Service Bulletin

Subject: Revised Front License Plate Bracket Installation Instructions

Models: 2014 - 2017 Cadillac CTS Sedan (VIN A)
With Front License Plate Mounting Package (RPO VK3)

This PI was superseded to update Model years. Please discard PIC5922B.

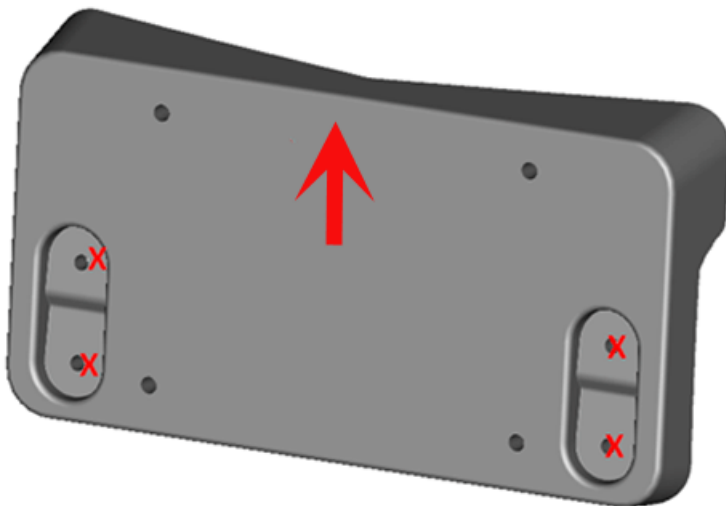
The installation of the front license plate bracket (if equipped) has been revised for better retention.

Do NOT use the rivets included in the trunk bag for installing the Front License Plate Mounting Package (RPO VK3).

If bolts and u-nuts are included in the trunk (small package with instruction sheet), use those to install the bracket following the instructions below.

If bolts and u-nuts are not in the trunk, order four (4) bolts and four (4) nuts to install the front bracket.

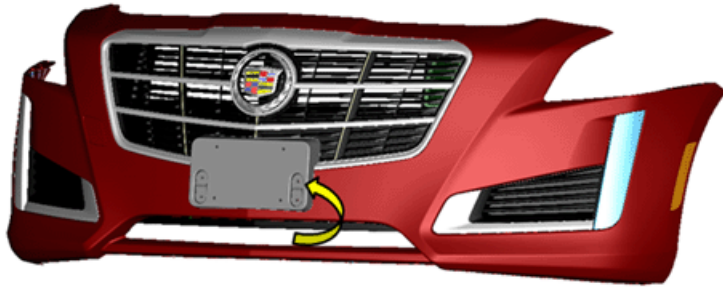
1. Drill 5.0 mm holes in all 4 location holes in bracket marked "X."

2. Install bolts through the license plate bracket and fascia holes.

3. Reach inside and behind the fascia (through the lower fascia opening) and install u-nuts on the backside. The u-nut is being used only as a nut, it does not clip on to any body parts.
4. Tighten bolts into u-nuts with a torque of (22 in lbs.) or (2.5 nm.).

Note: The license plate bracket **MUST** be mounted as shown above so that airflow through the fascia is not restricted and proper engine cooling occurs.
